CR and C2M host channel model parameters

Comments #92, #83

Adee Ran, Cisco

Figure 178A-2—Transmitter S-parameter model

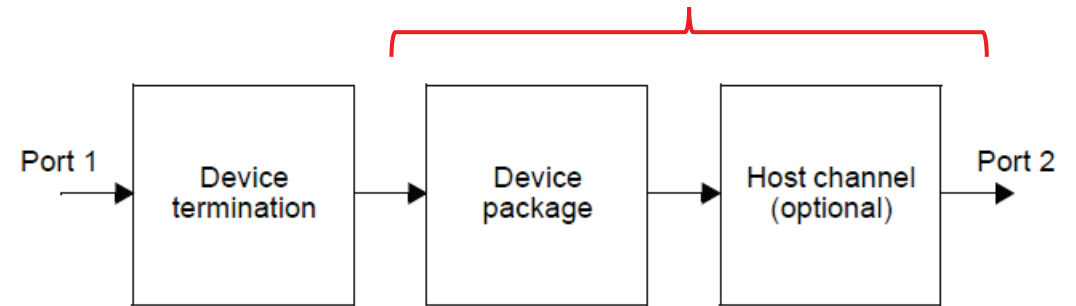
Should be
18.95

CR Host class	Max ILdd (TP0d-TP1 or TP4-TP5d)
HL	12.75-9.75=3
HN	17.75-9.75=8
HH	22.75-9.75=13

Figure 176D-6—Reference insertion loss budget at 53.125 GHz

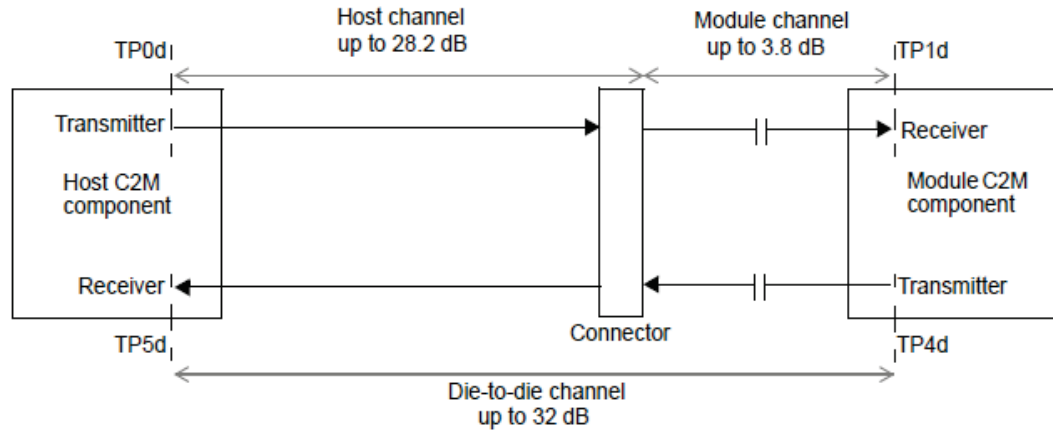
The response to comment #115 included the statements:
*“Based on the straw polls, there is consensus to use 32 dB as the TP0d to TP1a budget.
 Per ghiasi_3dj_03a_2409, the module ILdd allocation is 3.8 dB, same as the HCB.
 Therefore, TP0d to TP1d is also 32 dB.”*

C2M Host class	Max ILdd (TP0d-TP1 or TP4-TP5d)
(there is only one)	$32 - 9.75 = 22.25$

Figure 178A-2—Transmitter S-parameter model

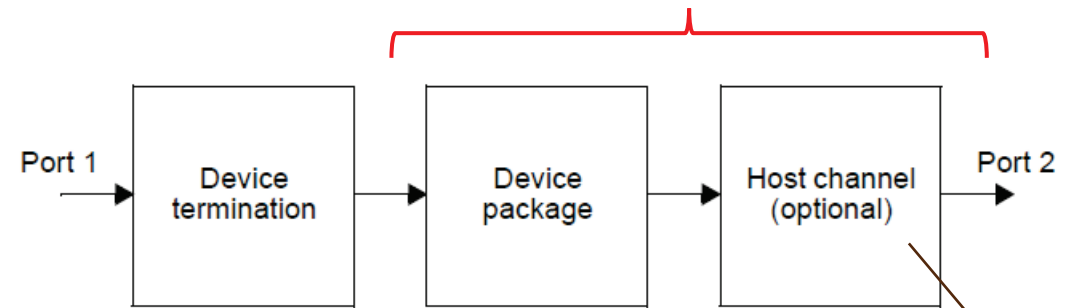
Note: This “Host channel” is not the same as the “Host channel” in the diagram on the top left. A different name could be considered.

Figure 178A-5—Host channel model

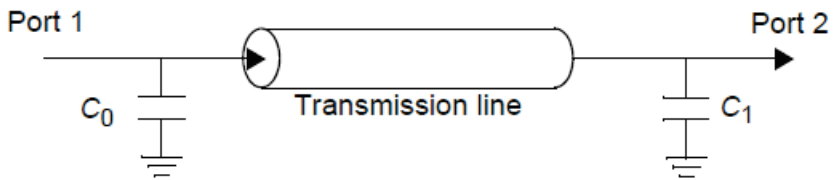
This “Host channel” row could be renamed to differentiate it from the host channel shown in Figure 176D-6.

Lengths (TBD) need to be adopted

Proposed CR host channel parameter values (comment #92)

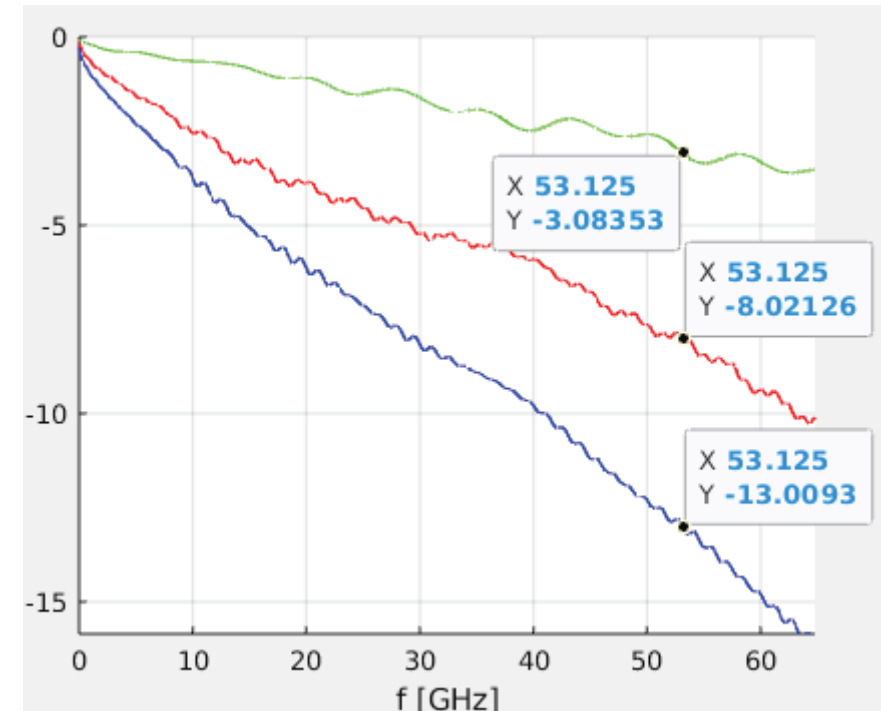
- For CR HL: assume a loss-optimized package (class A) with very short trace length, to enable some PCB loss
- For CR HH: assume radix-optimized package (class B) with long traces
- For CR HN: assume package class B with short traces
- For C2M: assume package class B with long traces

Trace lengths should be adjusted per case

Updated Table 179-18

Parameter	Host class			Units
	HL	HN	HH	
Package class	A	B	B	—
Package transmission line 1 length, $z_p^{(1)}$	8	15	45	mm
Host transmitter or receiver transmission line length, $z_p^{(h)}$	9	70	60	mm

Resulting ILdd [dB]

3 8 13

Proposed C2M host channel parameter values (comment #83)

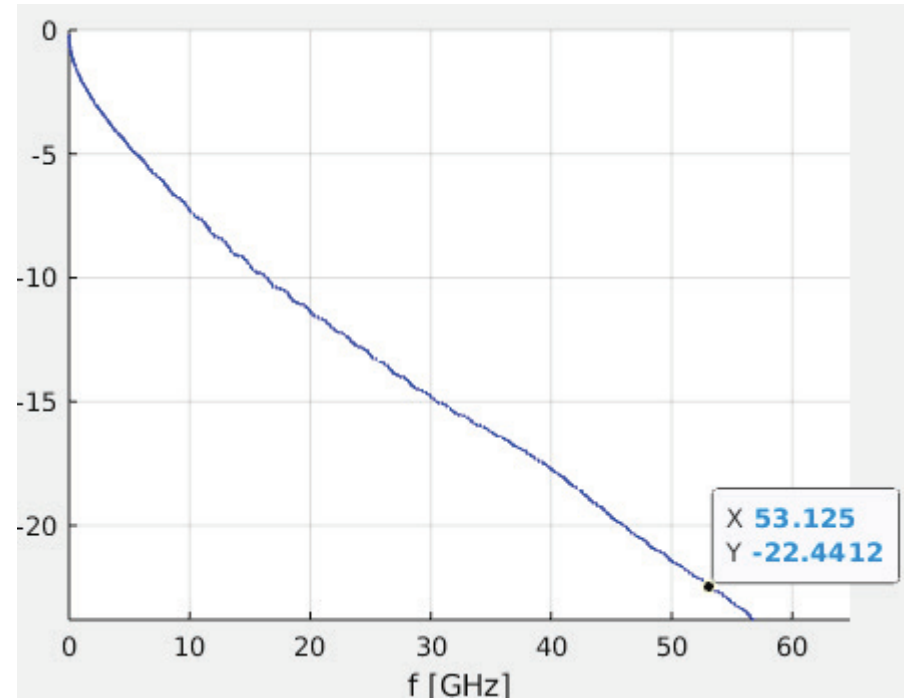
Change Table 176D-5

Parameter	Value	Units
Package parameters	<i>[Keep class B parameters, delete class A parameters]</i>	—
Package transmission line 1 length, $z_p^{(1)}$	45	mm
Host transmitter or receiver transmission line length, $z_p^{(h)}$	250	mm

Resulting ILdd [dB]

22.44
